UNITED STATES PATENT AND TRADEMARK OFFICE

APPLICATION NO.	FILING DATE	FIRST NAMED INVENTOR	ATTORNEY DOCKET NO.	CONFIRMATION NO.
10/099,775	03/15/2002	Jean-Christophe Jacques Kling	3206.2.1 NP	4985
7590 10/16/2006				
Starkweather & Associates 9035 South 1300 East #200 Sandy, UT 84094				
			EXAMINER HORTON, YVONNE MICHELE	
			ART UNIT 3635	PAPER NUMBER

Office Action Summary

DETAILED ACTION

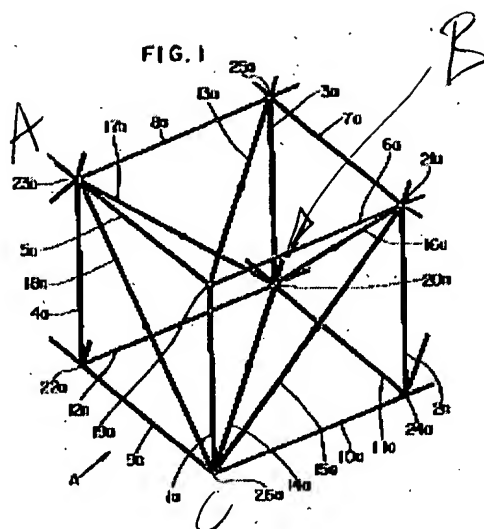
Claims 1-5,7-24 are rejected under 35 U.S.C. 103(a) as being unpatentable over US Patent #4,819,399 to ONODA. ONODA discloses the use of an architectural system including a triangular base (ABC) consisting of a first (17a), second (14a) and third (18a) strut aligned along first (AB), second (BC), and third (CA) axis; such that the first and third struts (17a,18a) form a first acute base angle (CAB), the first and second (17a,14a) struts form a second acute base angle (ABC), and the second and third struts (14a,18a) form a third acute base angle (BCA), see below; wherein the struts

(17a, 14a, 18a) each consist of at least two rigid pieces in that they can be folded (column 8, lines 4-8 and 53-54) and movable apart to form a strut elongation. The structure further includes a first node (A) engaging the first (17a) and third (18a) struts, a second node (B) engaging the first (17a) and second (14a) struts, a third node (C) engaging the second (14a) and third (18a) struts forming the base triangle (ABC) and base plane; and an extension (15a) consisting of a fourth strut aligned along a fourth axis (CD) that does not lie in the base plane of the triangular base (ABC), see the marked attachment. ONODA discloses the basic claimed structure except for explicitly detailing the exact dimensions of the angles forming the base triangle or the angle of the fourth strut. Although ONODA does not detail explicit angles that form the base triangle, it would have been obvious to one having ordinary skill in the art at the time the art was made to select an angle dimension suitable for the use intended as an obvious matter of design choice. For instance, larger width structures a larger angle dimension would be required; however, when a smaller size structure is being formed, a smaller angle dimension would be required. Also, the strength of the member forming the strut

or how the structure is intended to be used will determine the size of the angles that form the triangular base. In reference to claims 2-4, the fourth axis (CD) forms an angle (DBA) with the first axis; however, selection of the angle between the first and fourth axis or the angle of the fourth axis is also a matter of design choice, see also the marked attachment. Further, the applicant discloses a wide range of angle dimensions suitable for selection of the angle between the first and fourth axis, thus the applicant has shown no criticality for the selection of any one desired angle dimension.
